Product: MF-914 series, CPA-9000 series, CPA-7000 series, CPA-6100, CPA-6200

Please be informed that the resistance board used for the models above mentioned will be changed due to the discontinuation of the material. Please find the details below.

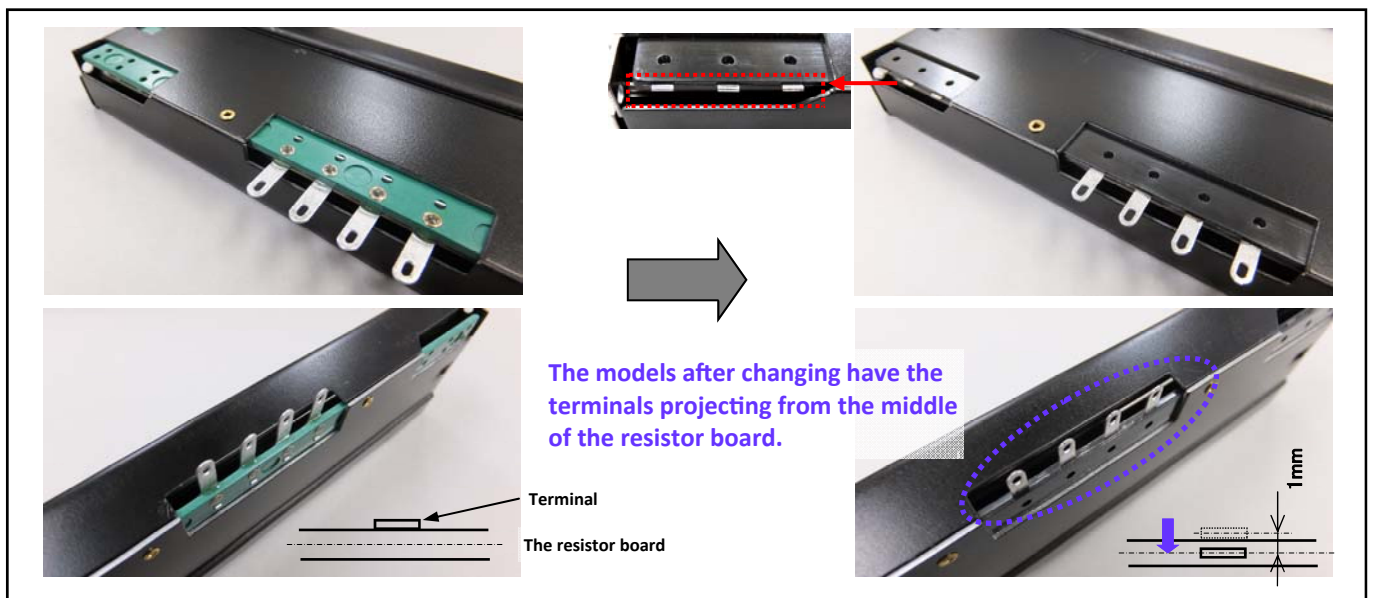
- The color of resin for the resistance board will be changed from green to black.
- There is no change in the electrical specification.
- The position of the terminals will be moved 1mm. (Please refer to the pictures below.)
- Due to construction for the stereo use, the unnecessary terminals will be cut for the mono spec.
- The size of the terminal will become smaller. (7.5mm→6mm length, 3mm→2.5mm width)
